BLACK ROSE: SKULL AND BONES SPEAKER WIRING DETAIL

**AUDIO BOARD
A-12738-20013**

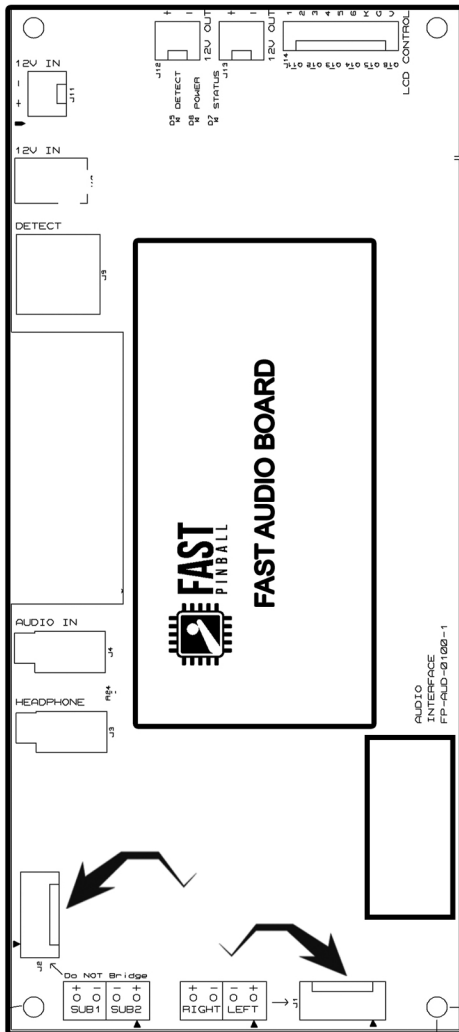
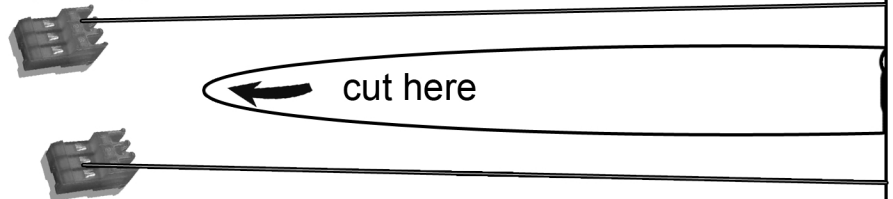
Original design has all speakers in series, back box and base cabinet, and this series loop connected to two different 4-pin connectors, one wire on each of J504 and J505

Remove the wires from these two 4-pin connectors and split or cut the series jumper between the back box speakers and the cabinet speaker so that you have 4 speaker wires.

Connect the 4 speaker wires as follows:

Connect the two wires that go to the backbox speakers to pins 1 and 2 of one 4 pin connector and plug that connector to the bottom right speaker connector on the FAST audio board (RIGHT or LEFT).

Connect the two wires that go to the base speaker to pins 1 and 2 of one 4 pin connector and plug that connector to the bottom left speaker connector on the FAST audio board (SUB 1 or SUB2).

Please make sure both sets of speakers observe polarity by having the wire with the stripe connect to the same polarity connection point.
